## Ducted Systems Technical Services: Service Tips Letter

Letter: ST-013-23

Subject: **Wolong ECM Outdoor Fan Motor Reliability Improvement**

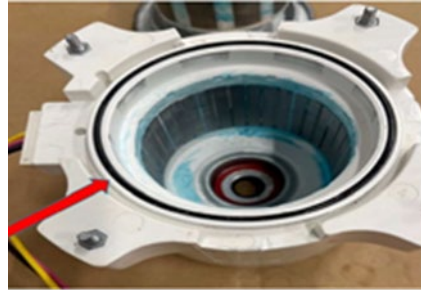
Motors manufactured prior to September 13, 2022, were susceptible to water ingress that could damage the rotor and stator as pictured below.

The manufacturer has now placed an O-ring seal between the cap and motor housing case. The O-ring seal implementation date was September 13, 2022.

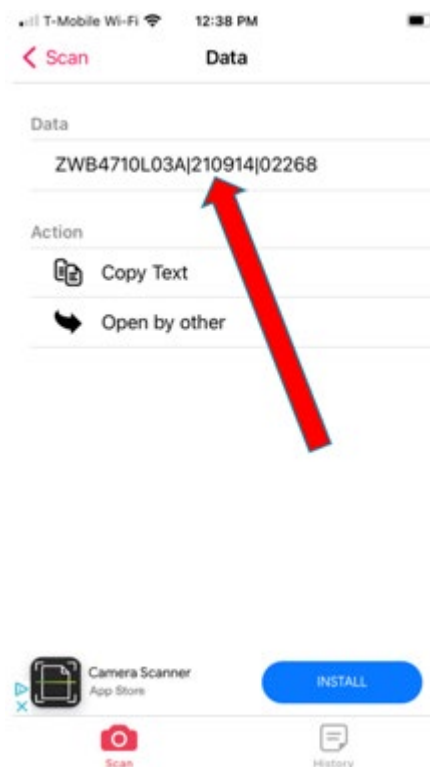
The motors are available through Source 1. The motor part number did not change. The motor date code will read as 20220913, year, month, and day. The date can only be identified from the information embedded in the QR code. Scan the QR code using a mobile device with QR code reader application.

Locate the 6-digit section of the data, in the example the date code is 210914, this particular motor was manufactured September 14, 2021.
